5 **DTR Station using the TXI Access Protocol**

7 **Join, Transmit and Monitor Low Level FSMs**

14 ⇒ Details of the changes to annex L requested  
15 by Ballot Comment KTW58. ⇐

16 This paper is a complete replacement for annex L in the P802.5r, Draft 6, October 1996 document.

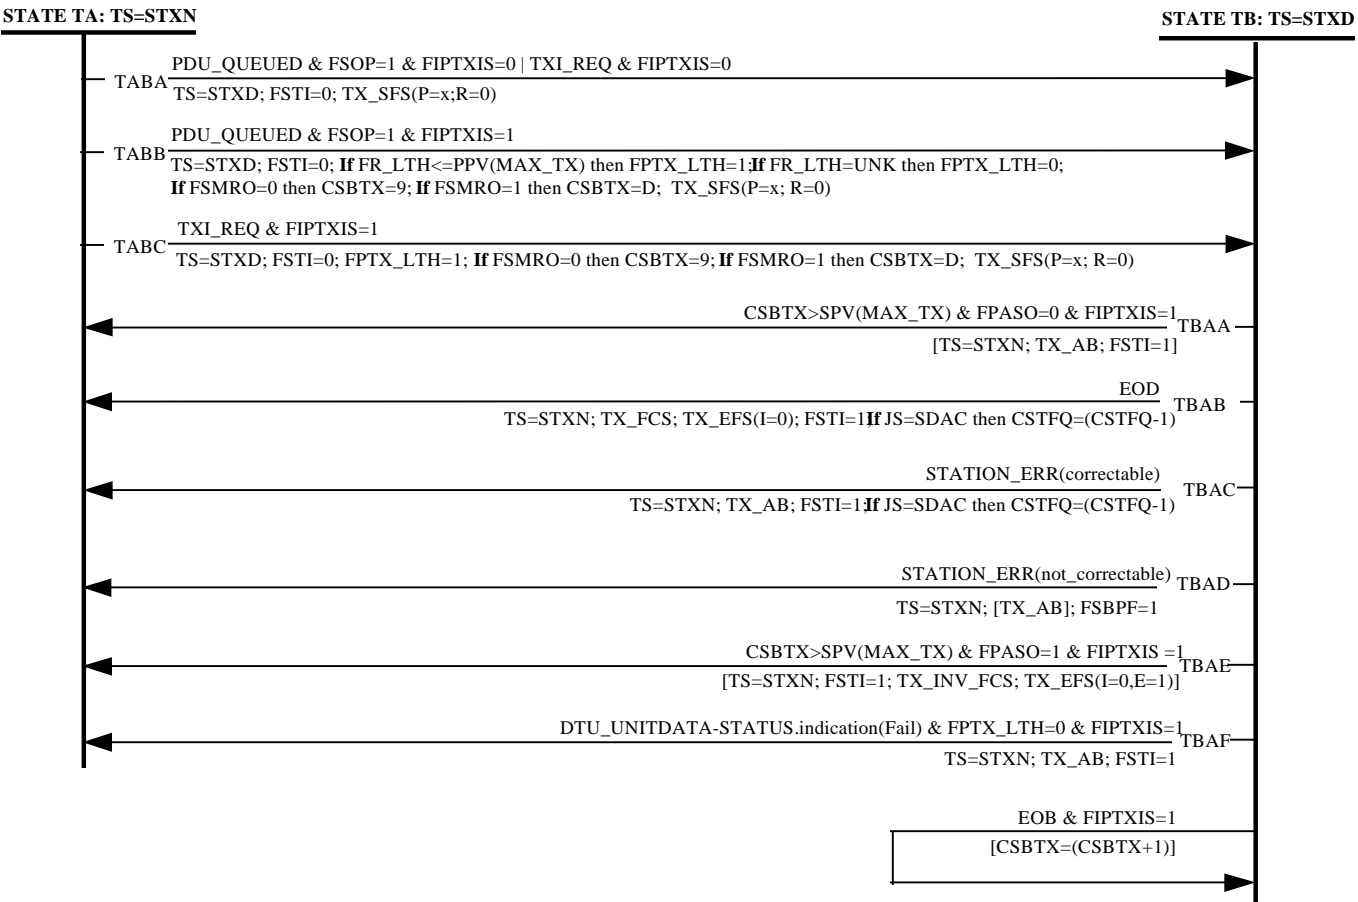
- 17 • Figure L-1 on page L-2, the Join FSM, is missing the 9.3 State J0 (JS=BP) starting point for the  
18 C-Port in Station Emulation Mode using the TXI Access Protocol.

19 This missing starting point, which is shown in figure 9.2-1 on page 9.2-2 (Station Operation Table:  
20 REF 1001 on page 9.2-12) and in figure 9.3-1 on page 9.3 (Port Operation Table: REF 1001 on  
21 page 9.3-14), has been added to figure L-1 as follows.
